SERVICE INFORMATION

RECALL

ZX750-E1 AND ZX1100-A2 THROTTLE WARNING AND RECALL NOTICE

Repair Procedure:

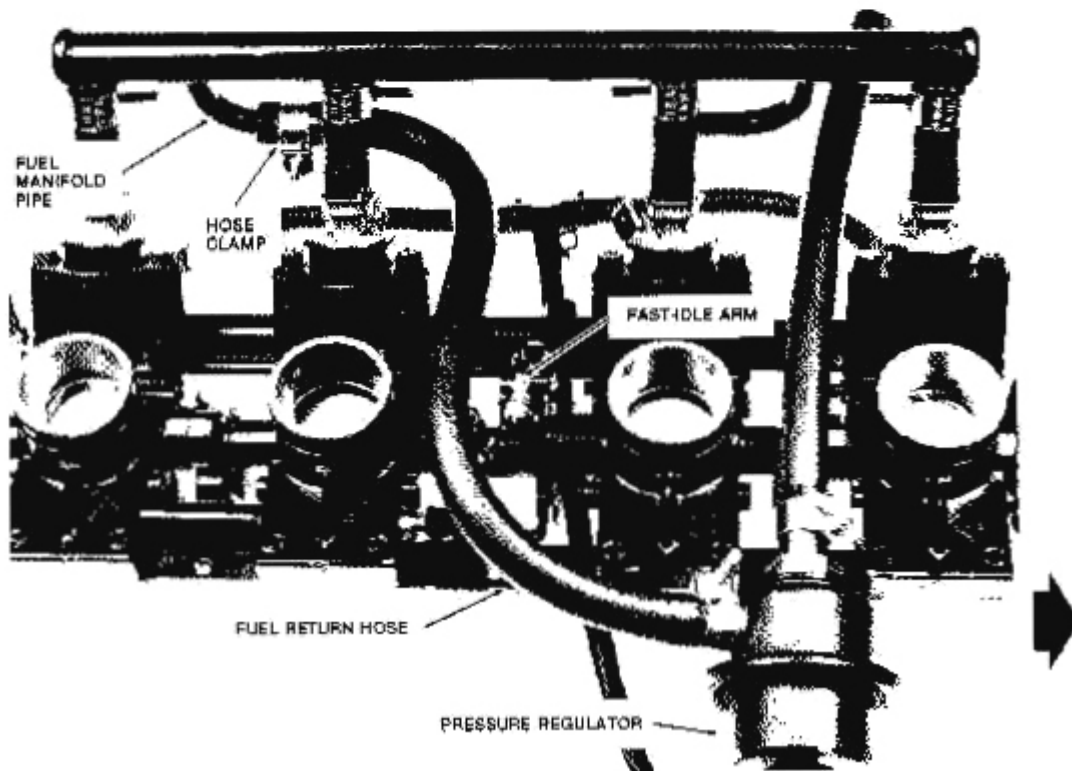
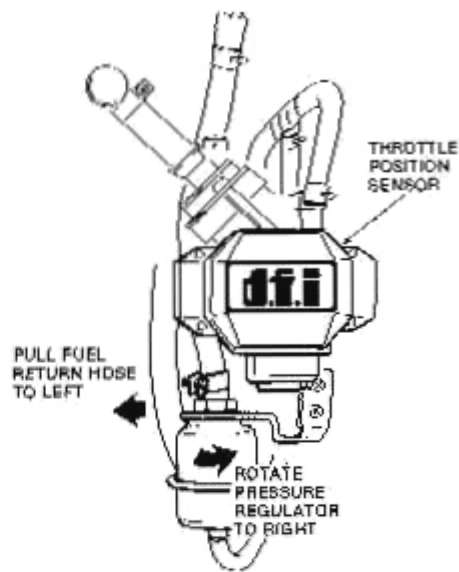
At or near wide-open throttle, a roller on the fast-idle arm of the throttle linkage can catch behind one of the fuel lines, causing the throttle to be held at or near the wide-open position. This could cause uncontrolled acceleration and a loss of vehicle control, resulting in an accident and possible serious injury or death.

Correct fuel return hose routing on all eligible units, including sold units in the field and unsold units in your inventory. Refer to Repair Procedure.

- Loosen the nut at the top of the pressure regulator.
- It may be necessary to loosen the regulator bracket mounting screws to remove the bracket for easier access to the nut.
- Rotate the pressure regulator as shown while pulling the fuel return hose to the left. This moves the fuel return hose against the air box and away from the throttle linkage.
- Be sure the pressure regulator does not move when you retighten the nut.
- Loosen the fuel return hose clamp at the fuel manifold pipe. Remove any twisting of the hose by rotating it on the manifold pipe. This also moves the hose back away from the throttle linkage.
- Operate the throttle to see that the throttle linkage does not come in contact with the fuel return hose.
- Tighten the hose clamp.
- Install the fuel tank.
- Reconnect the wiring to the throttle position sensor and install the wire clip.

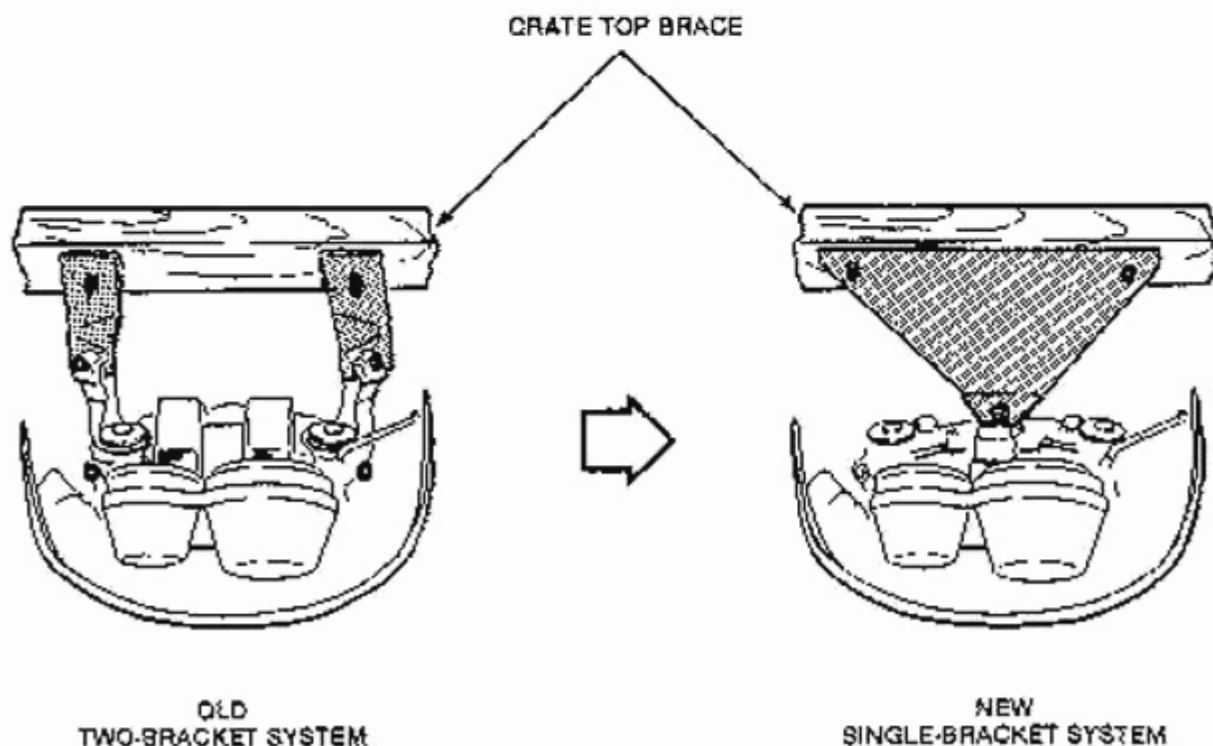
The new crating method for the ZX models uses a single bracket to hold the motorcycle's steering head to the crate. This bracket replaces the previous two-bracket system which secured the handlebar holders to the top brace of the crate.

The new bracket is attached to the steering head with the steering stem top bolt (or nut—ZX900) as shown.

- Remove the steering stem top bolt (nut) to remove the bracket.
- Reinstall the top bolt (nut) and torque it to 39 N·m (4.0 kg-m, 29 ft-lb).
- Check that the steering bearings are adjusted properly. Refer to the appropriate service manual and service bulletin MC 83-12 for instructions.
- Install the ignition switch cover with two screws.
- Refer to the General Assembly and Preparation Manual and appropriate supplements for all other uncrating, assembly, and preparation procedures.

**FUEL SYSTEM HOSE ROUTING
EXAMPLES—ZX800-A1/L**

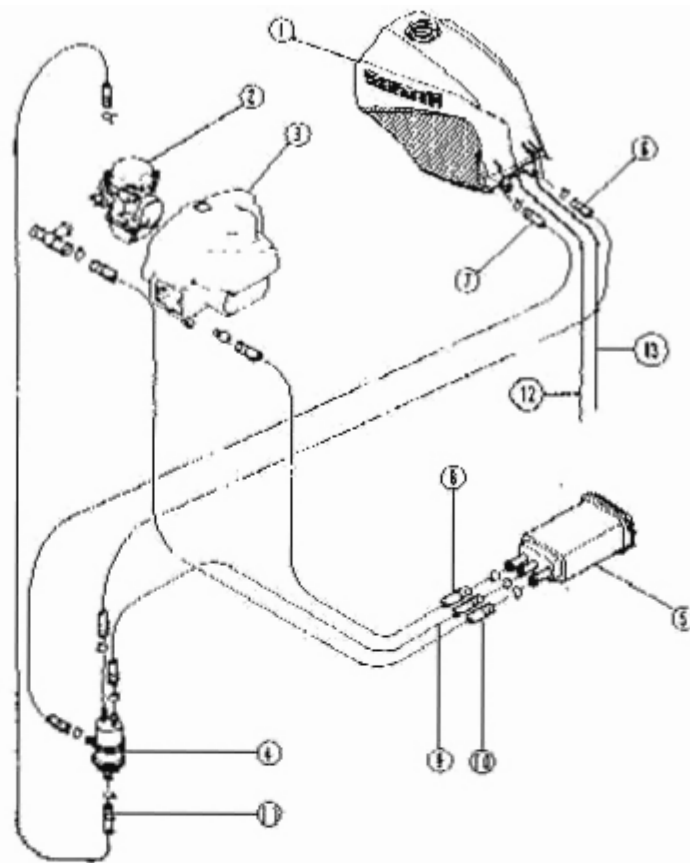
Symptom	Pinched Hose
Eccentric engine performance at high rpm or engine stops running as if out of fuel. Excessive pressure in tank causes sides to bulge.	Breather Hose—California model (blue) and 49-state model
Liquid fuel unable to return to the fuel tank can enter the canister and eventually cause hard starting and engine hesitation.	Fuel Return Hose (red)
Float chamber no longer vented to atmosphere results in hard starting, engine hesitation or engine stops as if out of fuel.	Carburetor Vent Hose—California model (yellow) and 49-state model
Fuel vapor cannot be purged from canister leading to vapor saturation of canister.	Purge Hose (green)
Same as pinched Fuel Return Hose (red)	Vacuum Pulse Hose (white)

Be sure to check hose routing while removing and installing the fuel tank or any other component that requires hoses to be disconnected or removed.

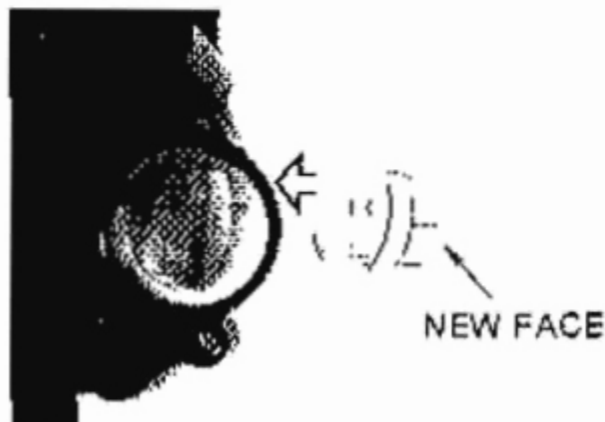
If the ZX750 Turbo engine oil is overfilled, the oil may run into the turbo unit while the motorcycle is parked on the side stand. The oil can then leak out of the turbo unit or cause exhaust smoking when the engine is started.

To help prevent overfilling, the factory has designed a new oil level sight gauge face. The new face lowers the high oil level mark by 6 mm. This reduces the maximum engine oil capacity by 0.3 liters to 3.2 liters (3.4 qt).

- Align the gauge face properly by fitting the tabs on the face into the slot in the clutch cover.

- While pressing the new gauge in, be sure the tabs stay in plane in the slot.
